CITY PLAN COMMISSION STAFF REPORT

CLD-FnPlat-2025-00019

Tiffany Square Apartments Final Plat

Plan Conditions

TIFFANY SQUARE APARTMENTS

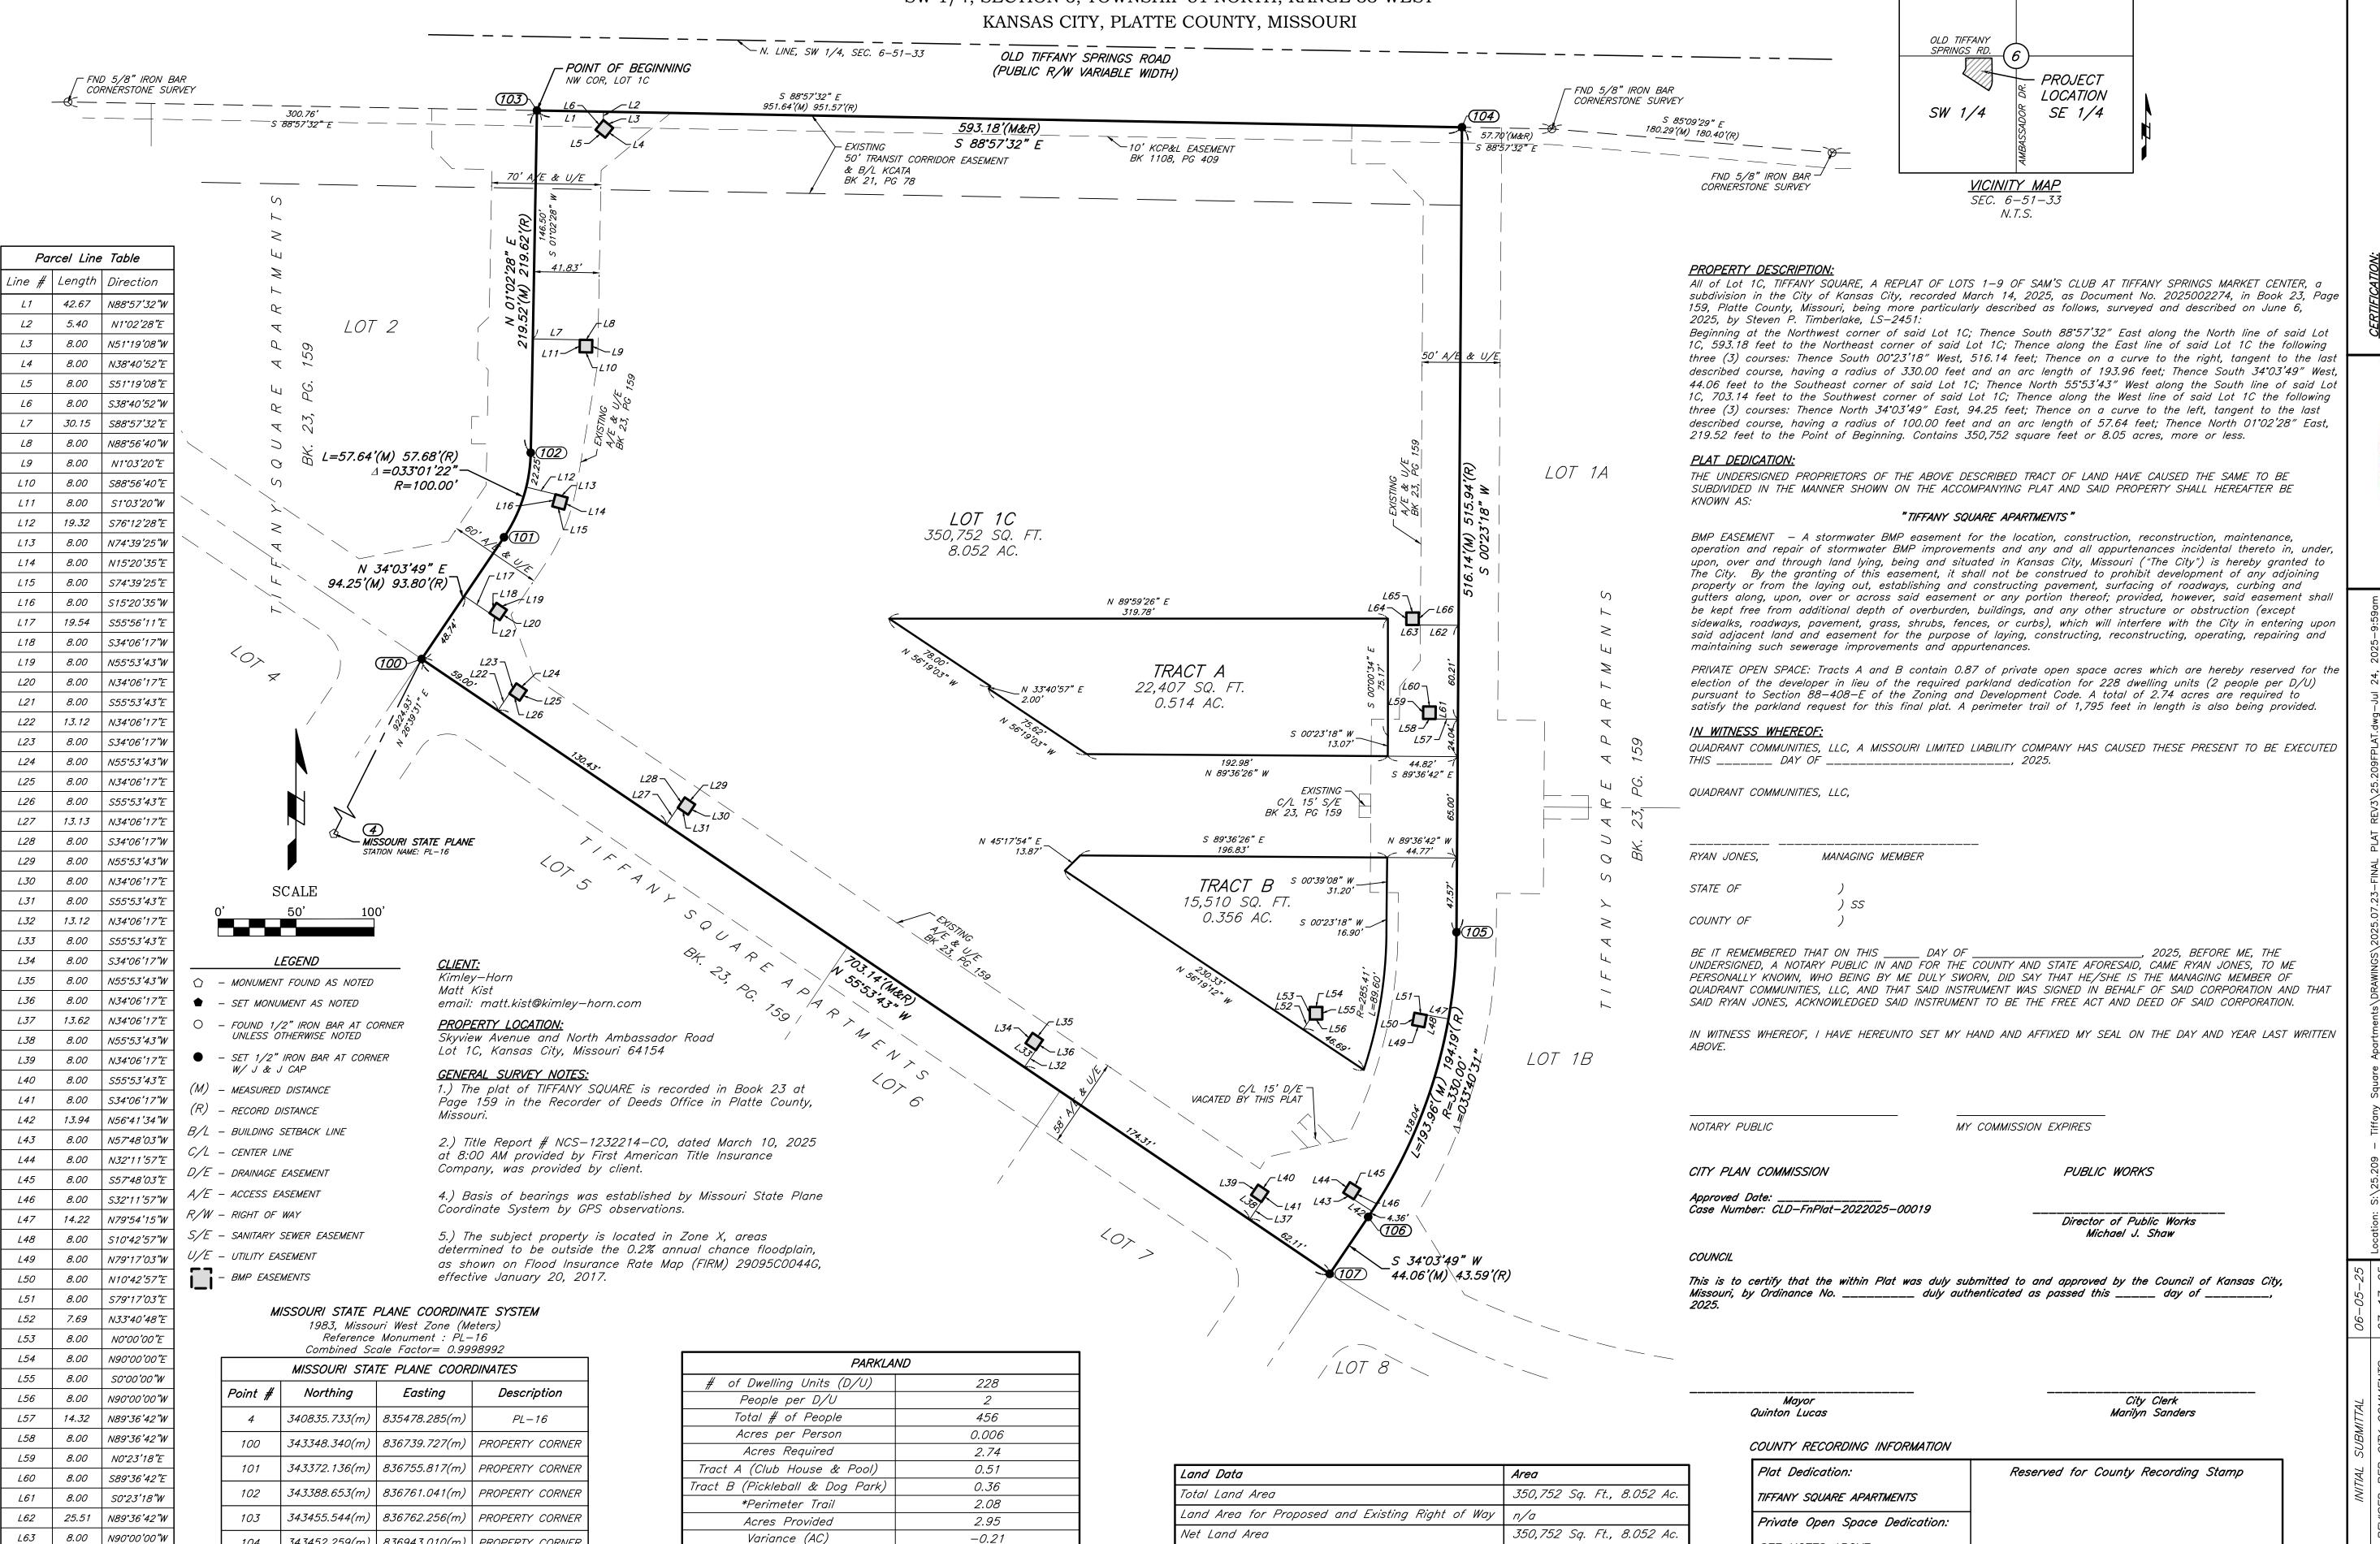
- 1. That prior to submitting documents for the final approval of conditions the applicant update the plat to reflect the correct City Plan Commission Date, Ordinance Number, and Council Approval Date by utilizing the Official City Signature Block found under Table 8 in the 2025 Director's Minimal Submittal Requirements and insert Case No. CLD-FnPlat-2025-00019.
- 2. That prior to submitting documents for the final approval of conditions the applicant ensure that the Title Report is current within 90 days or submit an updated Title Report.
- 3. That prior to submitting documents for final approval the applicant shall upload Paid Tax Receipts for the most recent applicable year.

4. The developer shall be responsible for dedication of parkland, private open space in lieu of parkland, or payment of cash-in-lieu of either form of dedication, or any combination thereof in accordance with 88-408. Should the developer choose to pay cash-in-lieu of dedicating all or a portion of the required area, the amount due shall be based upon the 2024 acquisition rate of \$64,220.18 per acre. This requirement shall be satisfied prior to certificate of occupancy.

- 5. The developer shall submit a streetscape plan with street tree planting plan per 88-425-03 for approval and permitting by the Parks & Recreation Department's Forestry Division prior to beginning work in the public right-of-way.
- 6. The developer shall be responsible for tree preservation in an easement or platted tract, mitigation planting, or payment of cash-in-lieu of preservation or mitigation planting, or any combination thereof in accordance with 88-424. Should the developer choose to pay cash-in-lieu of preservation or mitigation of all or a portion of the required area, the amount due shall be based upon the rate specified in 88-424. This requirement shall be satisfied prior to issuance of certificate of occupancy, or prior to the recording of the final plat, whichever occurs first.

- 7. The developer must grant a BMP for the proposed infiltration trench to the City as required by KC Water, prior to recording the plat or issuance of any building permits.

- 8. The developer must obtain the executed and recorded city approved grading, temporary construction, drainage/sewer, or any other necessary easements from the abutting property owner(s) that may be required prior to submitting any public improvements crossing properties not controlled by the developer and include said document(s) within the public improvement applications submitted for permitting.

- 9. The developer shall submit a detailed Micro storm drainage analysis from a Missouri-licensed civil engineer to KC Water showing compliance with the current, approved Macro study on file with the City and with current adopted standards in effect at the time of submission, including Water Quality BMP's, prior to approval and issuance of any building permits to construct improvements on the site or prior to recording the plat, whichever occurs first. The developer shall verify and/or improve downstream conveyance systems or address solutions for impacted properties due to flow contributions from the site; and that the developer construct any other improvements as required by KC Water as necessary to mitigate impacts from rate, volume, and quality of runoff from each proposed phase.

- 10. The developer must secure permit to connect to public storm water inlet serving the lot prior to issuance of a building permit.
- 11. The developer must secure permits to extend public sanitary and storm water conveyance systems to serve all proposed lots within the development and determine adequacy of receiving systems as required by KC Water, prior to recording the plat or issuance of a building permit whichever occurs first.
